V0033

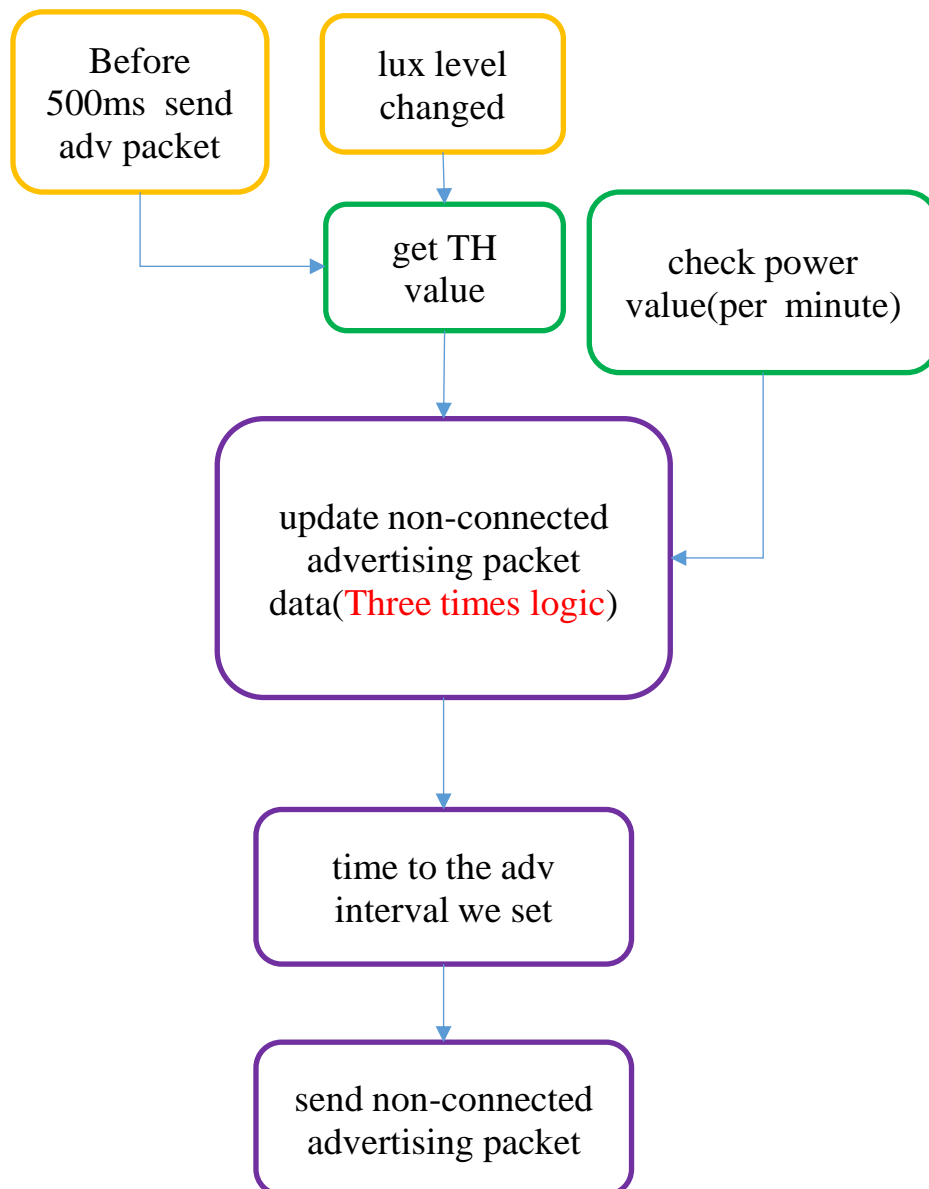
In v0033 revision, every time we update non-connected adv packet, we will do three times logic. But not every time we update data, it will send. When we check power value and get TH value it will update non_connected adv packet. However, the time get TH value and check power value is not at the same time. So in v0033, it may occur that we update several times non-connect adv packet, but only send once.

Because of the reason as shown earlier, we decided to take the three times logic in get TH value function. Only every time we get TH value, we do the three times logic. There are two places to get TH value. Before 500ms when send non-connected adv packet and when lux level change, it will change the adv interval, and get TH value right away.
